# CITY PLAN COMMISSION STAFF REPORT

The Collection at Staley Hills

**CD-CPC-2025-00076**, Development Plan

**CD-CPC-2025-00077**, Rezoning

SHEET  
C103

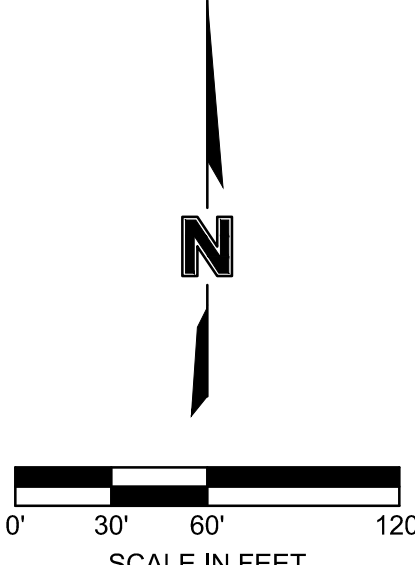
8. That the developer obtain a variance to the setback required by 88-323-03-A or revise the development plan to meet the R-2.5 district setback prior to issuance of building permit.

A VARIANCE REQUEST FROM THE BOULEVARD AND PARKWAY STANDARD SHALL BE MADE.

SHEET  
A101

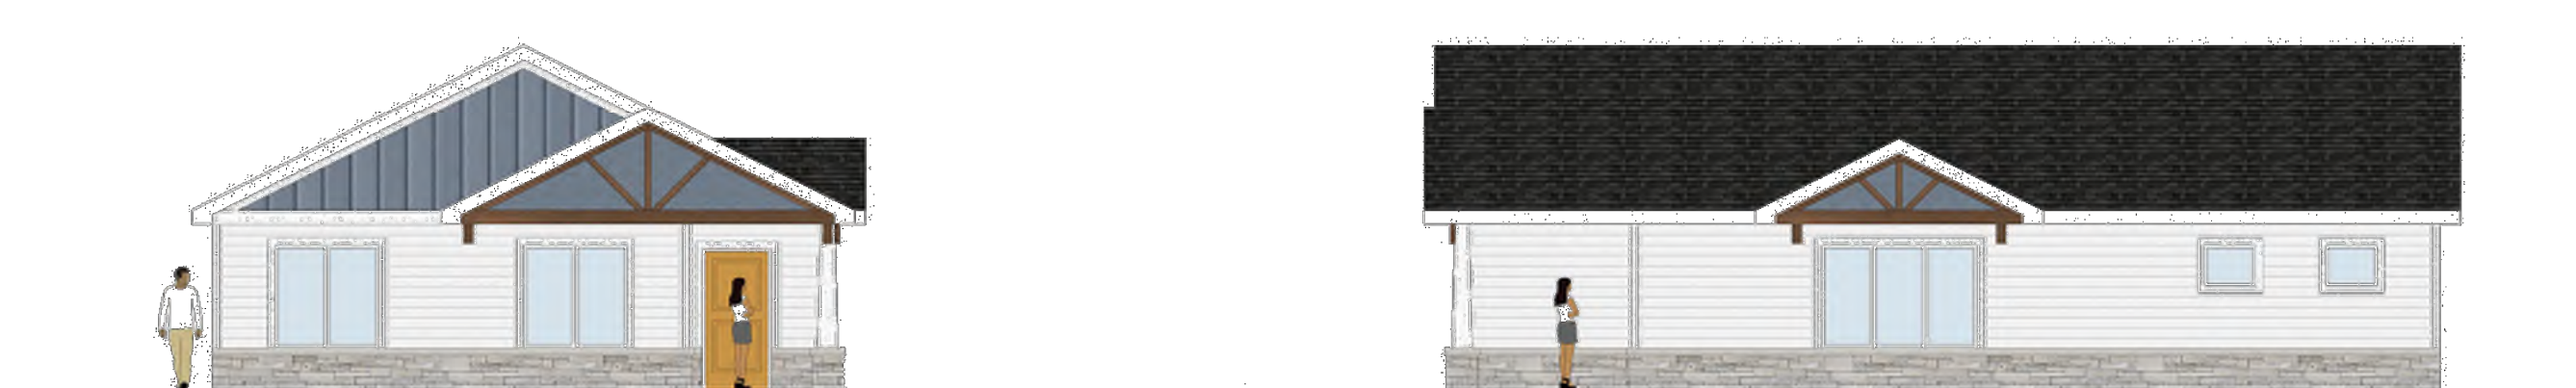
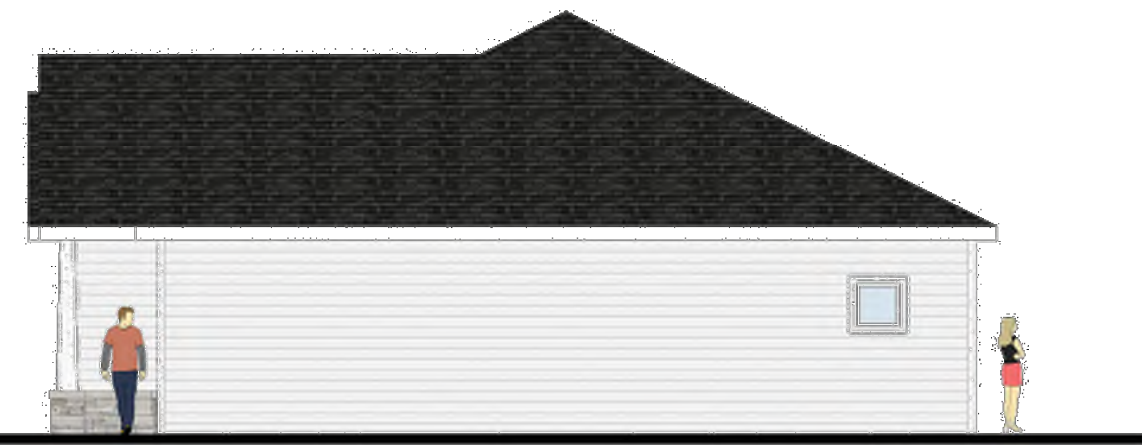
9. That the plan be revised to provide the following prior to ordinance request:
  - a) Provide labeled building palette for each building type. Call out building materials on the elevation plan sheets.
